INDESIT company

BCB313AAVEIS/HA

F048756

52221L0 Exploded views

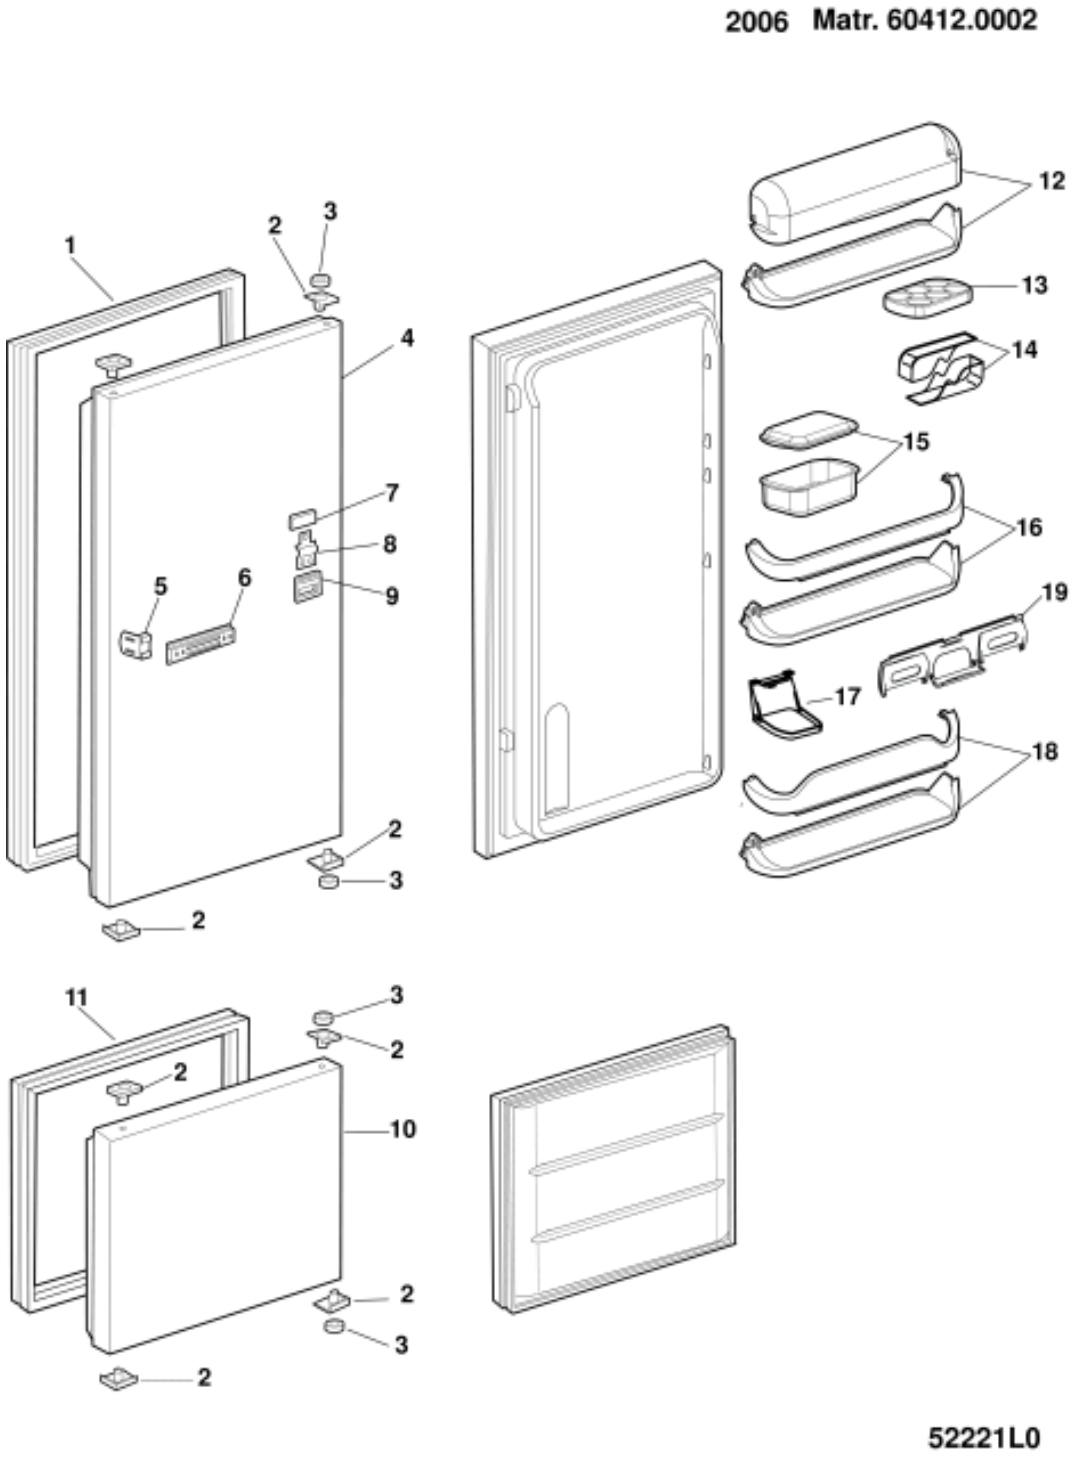
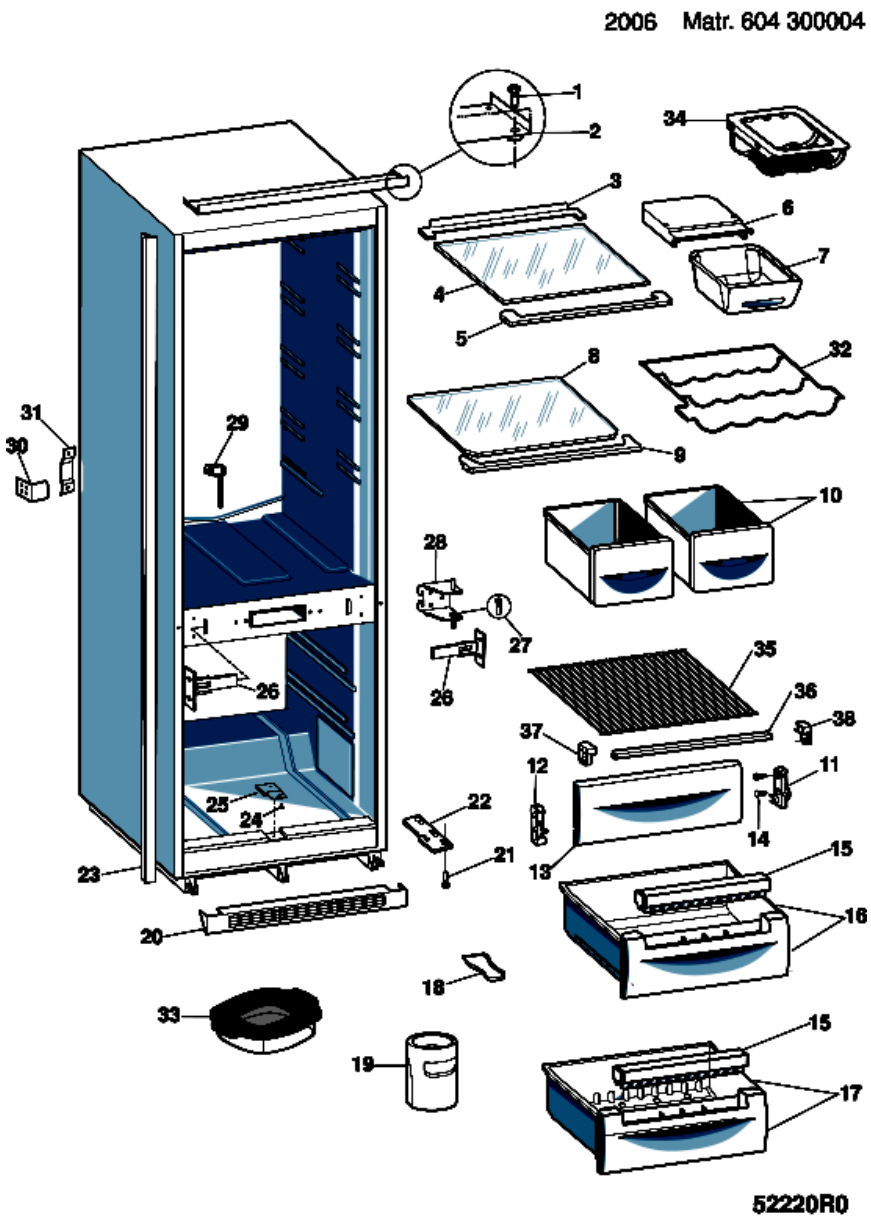
n3010j01: Colour Change of Internal Accessories

The colour of some of the internal shelves and accessories have changed to transparent. This affects models produced in Carinaro-

Manisa. Modification is functionally interchangeable therefore once the colour versions of the parts have depleted they will automatically substitute to its corresponding transparent parts. Some parts will have been made obsolete with no substitution.

Some parts have changed from Satin Finish to Shiny (Crystal) Finish. These parts include;
-Door Shelves
-Crisper Front Panels
-Freezer Drawer Front Panels
All pre-modification components will be managed till the end of stock and after they will be substituted with new version.

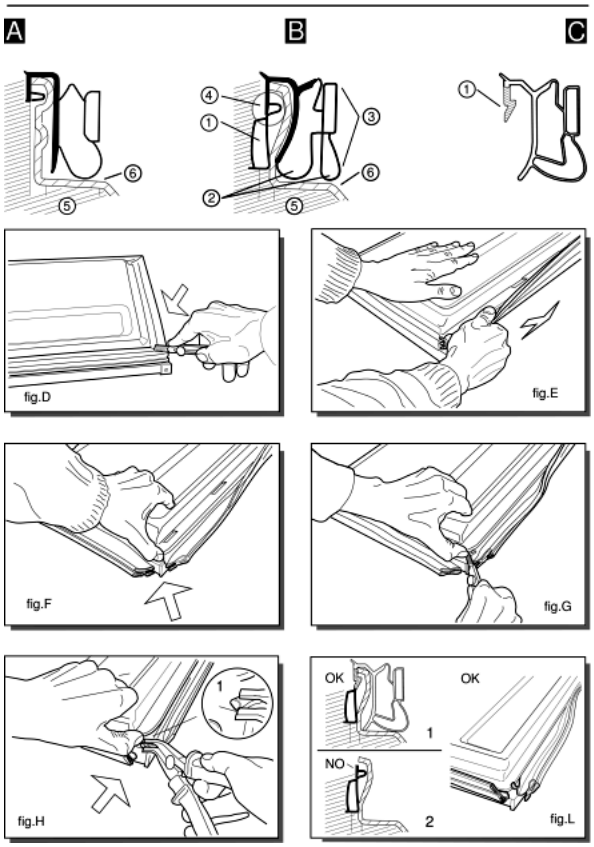
0522067: SEALS FOR DOORS FOAMED AS ONE PIECE

Various types of gaskets with different profile, as shown in figures (A) and (B), are used to fix the door (fig. A-5; B-5) and the inner door (fig. A-6; B-6) on the block foamed doors of combined freezers and refrigerators.
---Ilpea profile 245; 179; 412 (fig.A)
---Ilpea profile 287 (fig.B)
When replacing gaskets with profiles 245; 179; 412 these are fixed with screws (2 per corner) to the door.
Gaskets with profile 287 can not be used as spare parts but are designed to house the Ilpea type 900 gaskets (see figure C).
When replacing the gasket (287), once it is removed you will find a pocket (fig. B-1) between the door and inner door.
The rigid tooth (fig.C-1) of the gasket (900) is inserted inside between the pocket and the inner door, doing away with the need for screws.
Gasket with profile 287 is easy to identify since it has an exterior double edge (fig.B-2) which acts as a cushion when the door is closed.

To replace this gasket, follow these steps:
---Dismount the door and cut the four corners of the gasket along the joint (fig.D);
---lift the gasket and pull it carefully along its full length without tearing it (fig.E).
The purpose here is to detach the inner door slightly from the foam along the exterior edge for a depth equal to that of the gasket (fig.B-3);
---lift the corner of the inner door slightly, prising it up with your thumb (fig.F). Do not use a tool which might break the inner door;
---continue cutting the gasket inside the inner door for about 6 mm (fig.G);
---push in the tip of the pliers (type USAG N131) and pull outwards until you see the top edge of the pocket (fig. B-4) which is empty (fig.H-1);
---if you carry out this operation correctly (fig.L) you will be able to pull off the top edge of the pocket for the full length of the door.
If the gasket tears before the top edge (fig. L-2) you should repeat this operation from the other corner of the door.

---once the gasket (287), has been removed the space above the pocket (fig. L-1) can house the rigid tooth (fig. C-1) of the gasket 900.
When you fit this gasket ensure that it lies flush against the edge for the full length of the door.
If the rigid tooth is difficult to fit, eliminate any residues of foam between the door and the inner door in the gasket area.
fig.5131549A
